Application Note

Replacement for “Mini”-Sensors in combination with an amplifier

LS 05 GA-G + Amplifier possible solution with a standard sensor

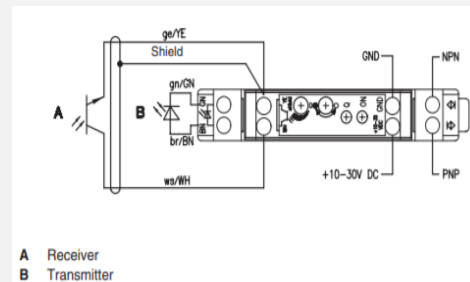
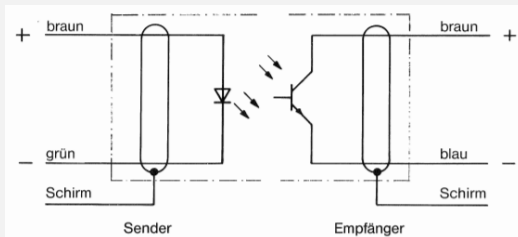
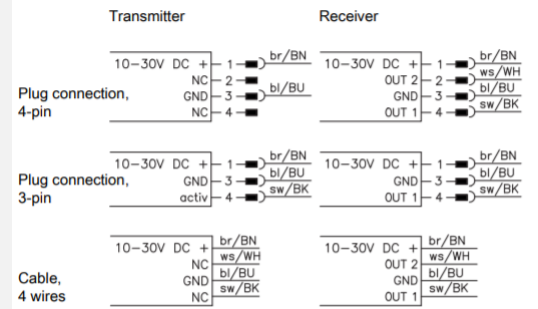
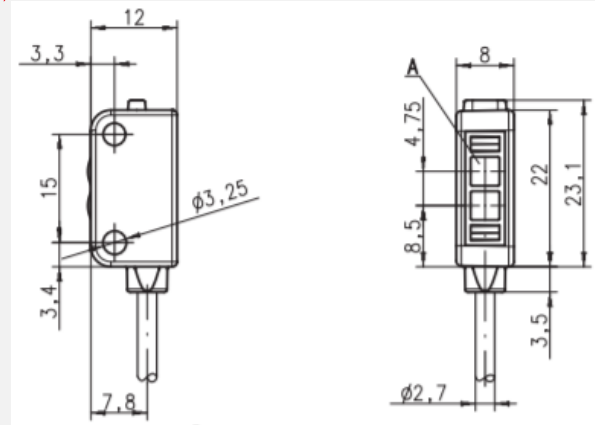
DISCONTINUED

No amplifier!

Voltage: 10-30VDC

Output: 1x NPN, 1x PNP

REPLACEMENT

LSR 2

LSSR 2

LSER 2/42

LS 05 GA-G + Amplifier possible solution with fiber-optics

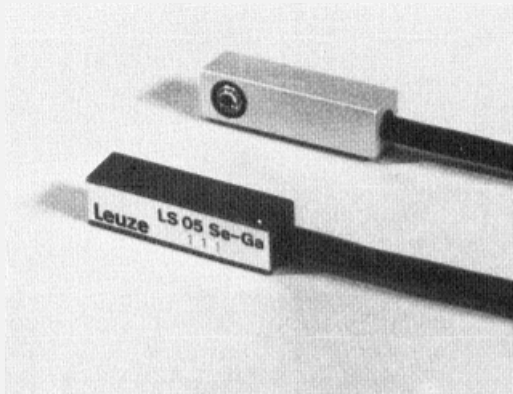
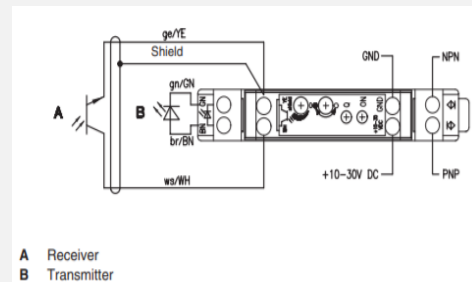
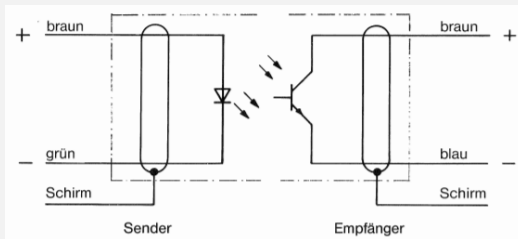
DISCONTINUED

REPLACEMENT

KF-LH-305-D - Plastic fiber optics for throughbeam operation

LV461.1/P2 - Fiber optic amplifier
